**Re: Petition for Reconsideration and Request for Partial Administrative Stay of EPA’s Final Rule:  
“Greenhouse Gas Reporting Rule: Revisions and Confidentiality Determinations for Petroleum and  
Natural Gas Systems”**

Petition for Reconsideration and Request for Partial  
Administrative Stay of EPA's Final Rule: "Greenhouse Gas  
Reporting Rule: Revisions and Confidentiality  
Determinations for Petroleum and Natural Gas Systems"

Docket ID No. EPA-HQ-OAR-2023-0234

Figure 1: Copied from "Figure 3.1.1 Parity plot for Methane K-values for Data from RR-23, 40, and 193" from Mamrosh et al.

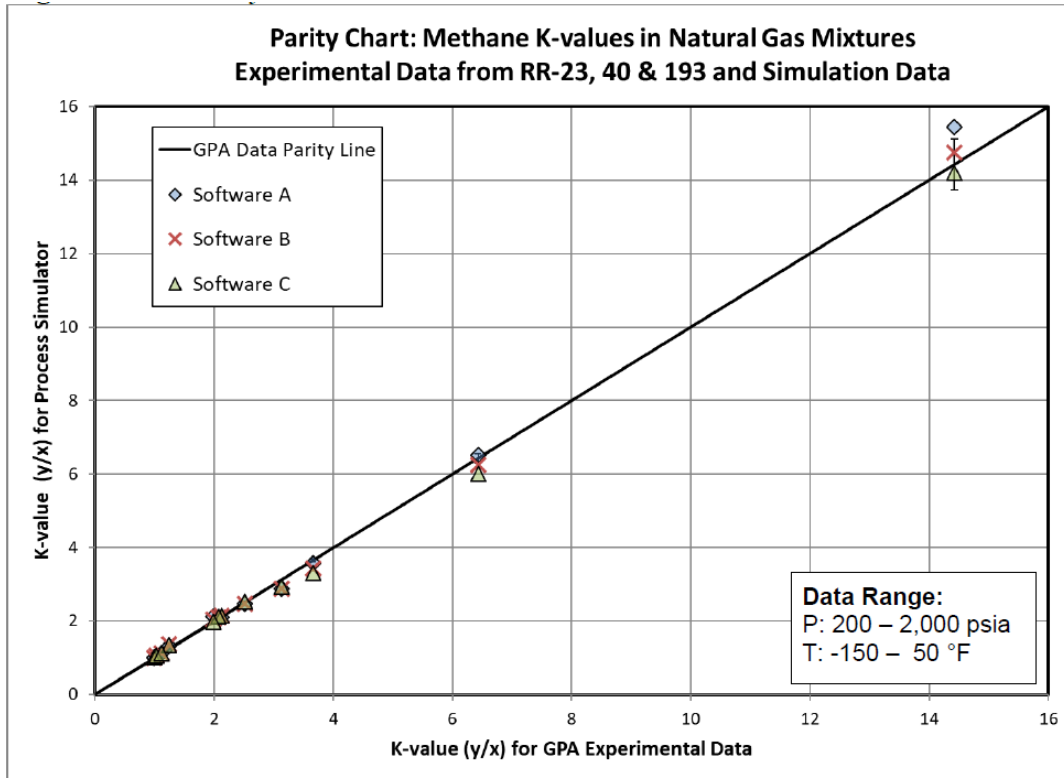
graphed on the x-axis and the simulation value on the y-axis, such that the parity line is the experimental data, and the simulation predictions are the points shown on the graph. In this source, the error bars shown are those of the experimental data. This research report utilizes an equilibrium constant K-value (a representation of solubility) for convenience in comparing Vapor-Liquid Equilibrium data. This shows that process simulators are typically very accurate at predicting methane content from AGRUs.

Figure 2: Copied from “Fig. 2. Simulator vs. operating data for sweet gas CO<sub>2</sub> concentration” in Pieronek et al.

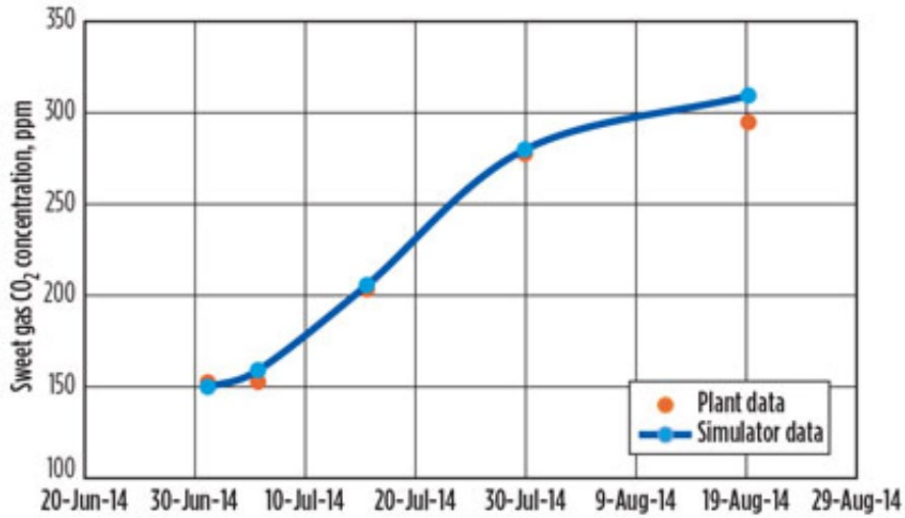
Similarly for CO<sub>2</sub> in AGRUs, the figure below from Pieronek et al.<sup>65</sup> shows very good agreement between data and simulation.
